Access Compliance Report

Public Rights-of-Way

(Curb Ramps)

Intersection ID: N/A	Main Street: COSTIGAN_LN	Cross Street: BALLANTYNE_VILLAGE_WY	Location: E
ADA ID: 333E2BD6305A	Ramp Type: PerpDiag	Initial Pass/Fail: Fail	Overall Compliance: No
Severity Score: 21.25			
Codes/Mitigation Info/Possible Solution		Field Measurements/Component Compliance

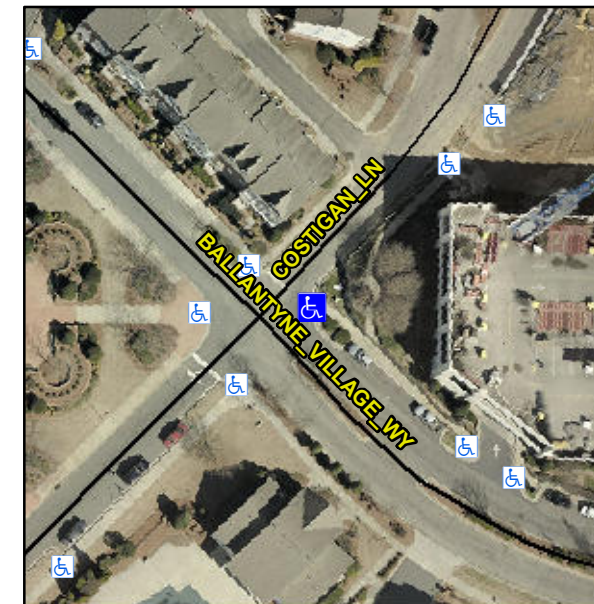
Not Found, R304.5.1, R304.5.3

Compliance	Description	Data	Compliance	Description	Data
N/A	Ramp Length (in)	52.0	Yes	Ramp Slope (%)	6.7
No	Ramp Width (in)	46.0	No	Ramp XSlope (%)	5.5
N/A	Flare Type LT	N/A	N/A	Flare Type RT	N/A
N/A	Flare Slope LT (%)	N/A	N/A	Flare Slope RT (%)	N/A
N/A	Flare Traversable LT?	N/A	N/A	Flare Traversable RT?	N/A
N/A	Landing Length (in)	N/A	N/A	DWS Provided?	N/A
N/A	Landing Width (in)	N/A	N/A	DWS Contrast?	N/A
N/A	Landing Slope (%)	N/A	N/A	DWS Length (in)	N/A
N/A	Landing X Slope (%)	N/A	N/A	DWS Full Width?	N/A
N/A	Landing Curb? (Y/N)	N/A	N/A	DWS Offset (in)	N/A
N/A	Shared Landing?	N/A			
N/A	Gutter Ponding?	N/A	N/A	Gutter Slope (%)	N/A
N/A	Gutter Lip Ht (in)	N/A	N/A	Gutter X Slope (%)	N/A
N/A	Painted X Walk1?	No	N/A	Painted X Walk2?	No
	X Walk 1 Direction	To NW		X Walk 2 Direction	To SW
N/A	X Walk 1 Width (in)	N/A	N/A	X Walk 2 Width (in)	N/A
	X Walk 1 Slope (%)	0.6		X Walk 2 Slope (%)	2.3
	X Walk 1 X Slope (%)	2.4		X Walk 2 X Slope (%)	0.6

Remove & Replace Curb Ramp With Two New Directional Ramps or Equivalent.
